Monterey Bay Aquarium Research Institute 7700 Sandhold Road, Moss Landing, CA 95039	
		Title	
		Phantom 2000: System	
Engineer Alana Shusterman, x1780	Size C	Document Number C	Layout File -Layout File-
Layout	Date	Rev	Rev
Monday, March 18, 2008		Sheet	1 of 1

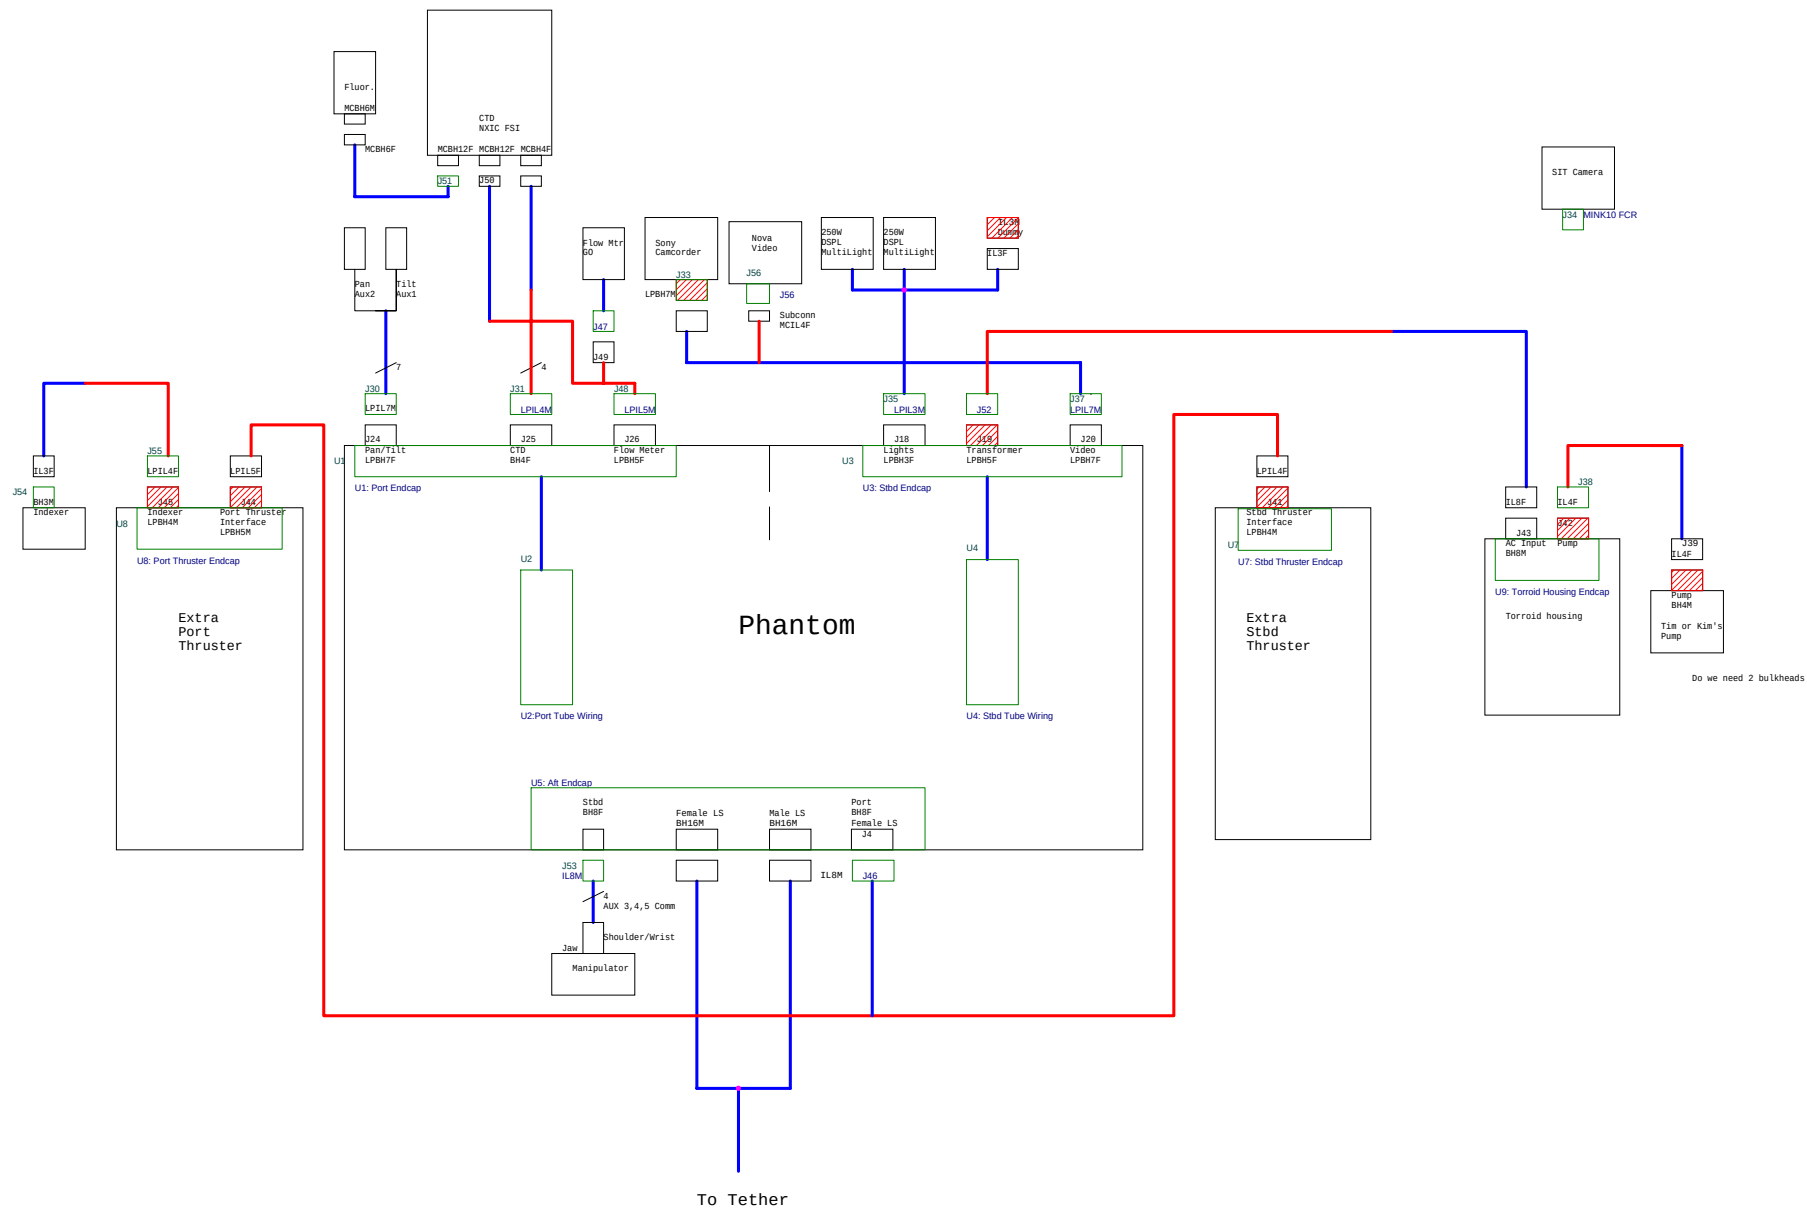
Do we need 2 bulkheads
